CHANGE ORDER PROPOSAL REQUEST
Additions and Alterations to
Hurricane Deck Elementary School
Arch. Project # 3-13021

Bloomsdale Excavating Company is pleased to submit the following additional pricing for the above referenced project. Our price is based upon constructing the Rock Buttress per the detail provided by PPI as part of the Slope Stability Analysis dated December 16, 2013 and is to be installed as shown on drawing C4.1 dated 12/16/13.

Re: Camdenton R-III School District
Hurricane Deck Elementary School – Slope Stability Analysis – Phase I
Sunrise Beach, Missouri
PPI Project Number: 218802

TOPOGRAPHIC SURVEY & FINISHED CONTOURS

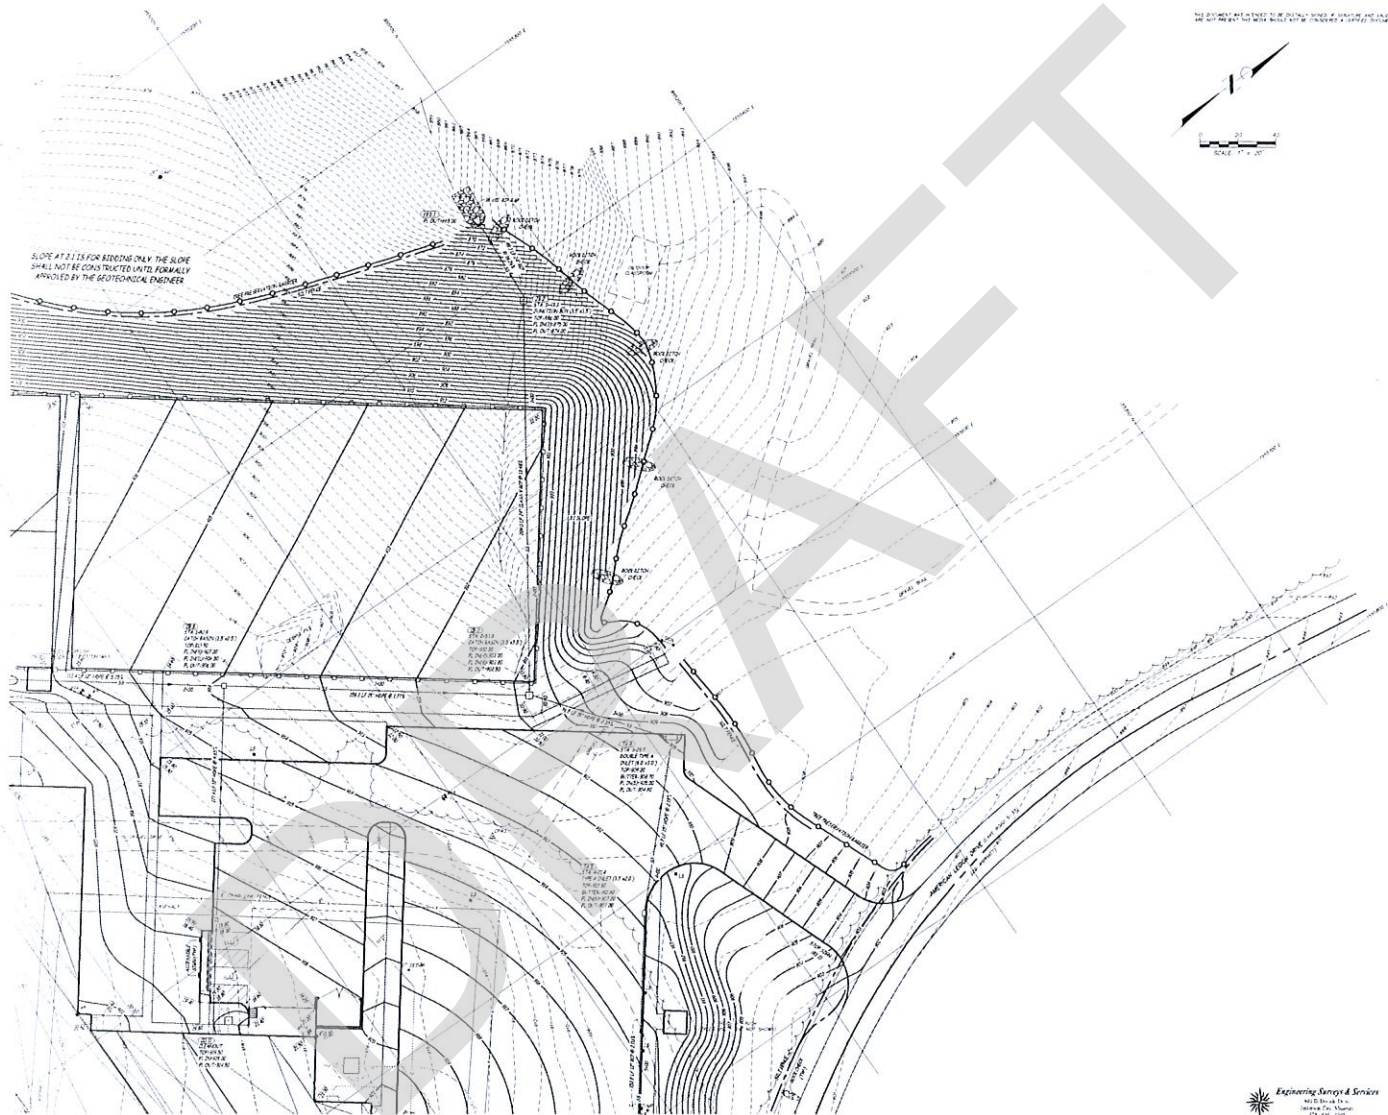
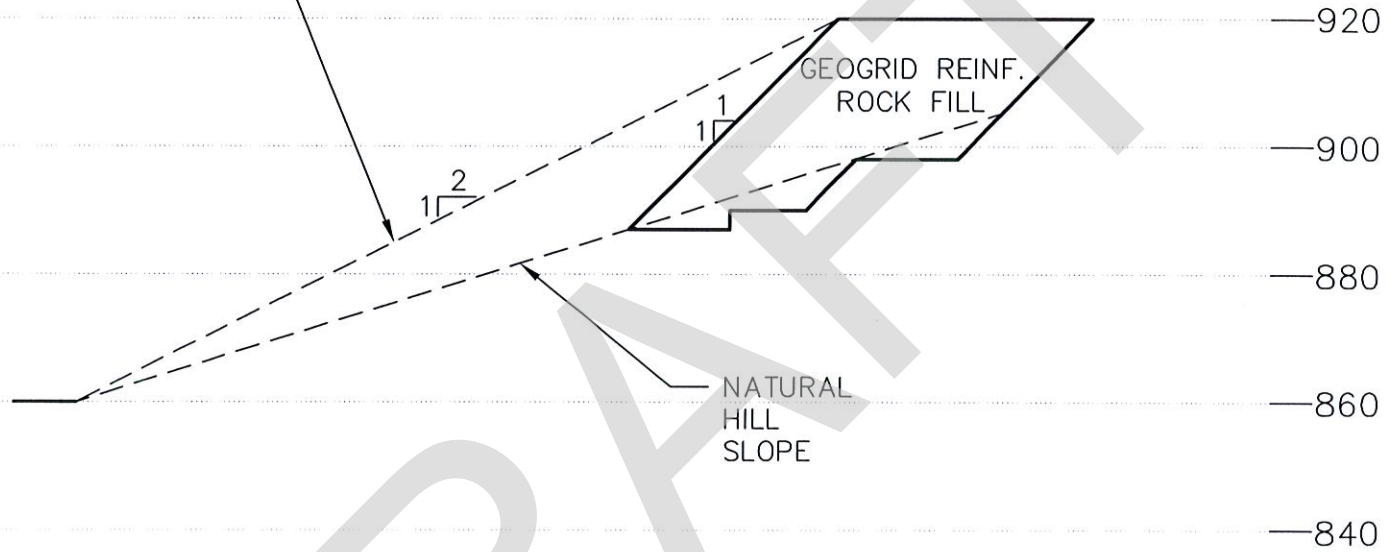
SLOPE AT 2:1 FOR RETAINING ONLY. THE SLOPE SHALL NOT BE CONSTRUCTED UNTIL FORMALLY APPROVED BY THE GEOTECHNICAL ENGINEER.

Slope Stability Analysis - Case 4

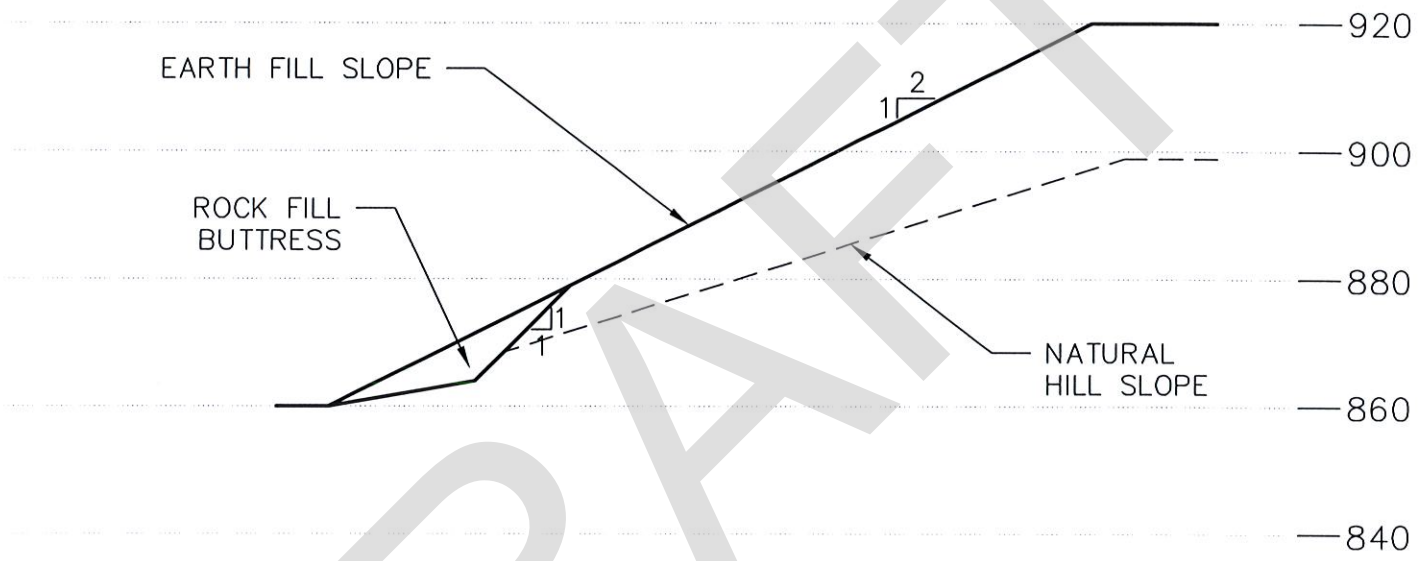
4. **2H:1V Earth Fill with Rock Fill Buttress at Toe** – This approach utilizes the simple earth fill slope at 2H:1V, but incorporates a rock fill buttress at the toe to increase safety factor and improve subsurface drainage. **As described in a later section of this report, placement of a rock fill toe drainage is recommended regardless of the slope configuration selected.** Safety factor of earth fill slopes can be increased by incorporation of a rock fill buttress. A typical cross section of this alternate is also provided in Attachment B. It is believed that safety factors on the order of 1.3 can be achieved with this approach.

Rock Buttress Detail

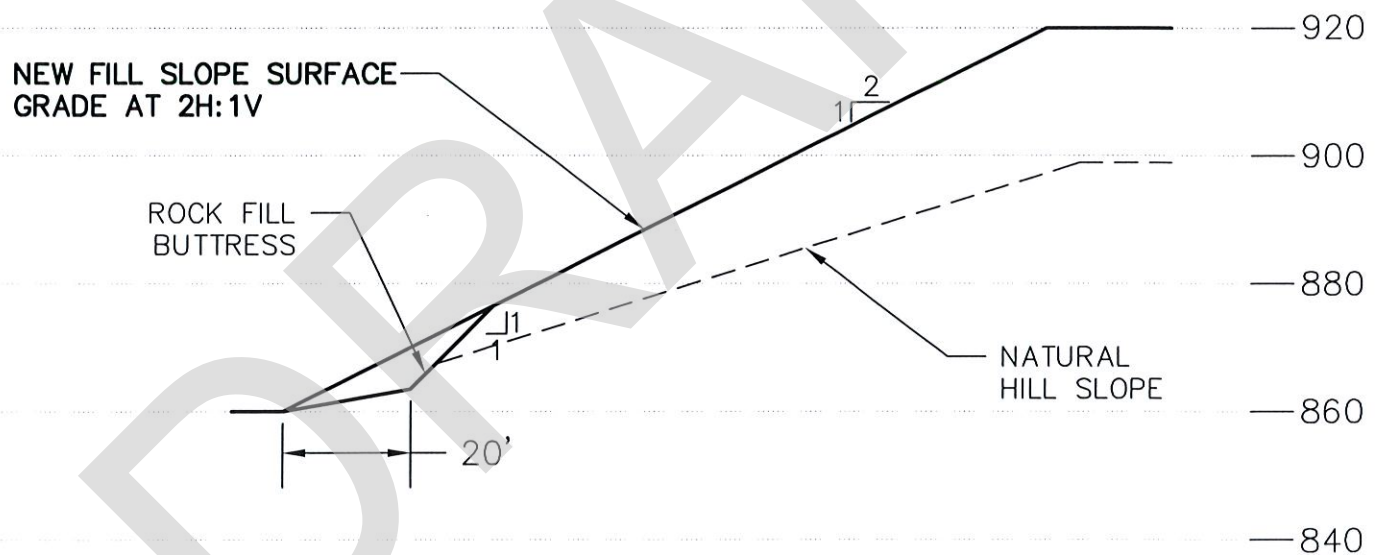
For simple 2H:1V slopes exceeding 50 ft. in height, it is recommended that a rock fill buttress be added to increase the slope stability Factor of Safety and to reduce erosion at the toe. A detail for this rock fill buttress is shown in Attachment C.

1. TOE ROCK BUTTRESS TO HAVE HORIZONTAL WIDTH OF 20 FT AND BACKSLOPE OF 1H:1V TO INTERSECT WITH NEW SLOPE FACE.
2. ROCK FILL GRADATION AND PLACEMENT IN ACCORDANCE WITH MoDOT 203.4.17 ROCK EMBANKMENT.
3. FILTER FABRIC MAY BE REQUIRED IF ROCK FILL GRADATION IS OPEN WITH CONSPICUOUS VOIDS.
4. FOR SLOPE HEIGHTS EXCEEDING 50 FT.
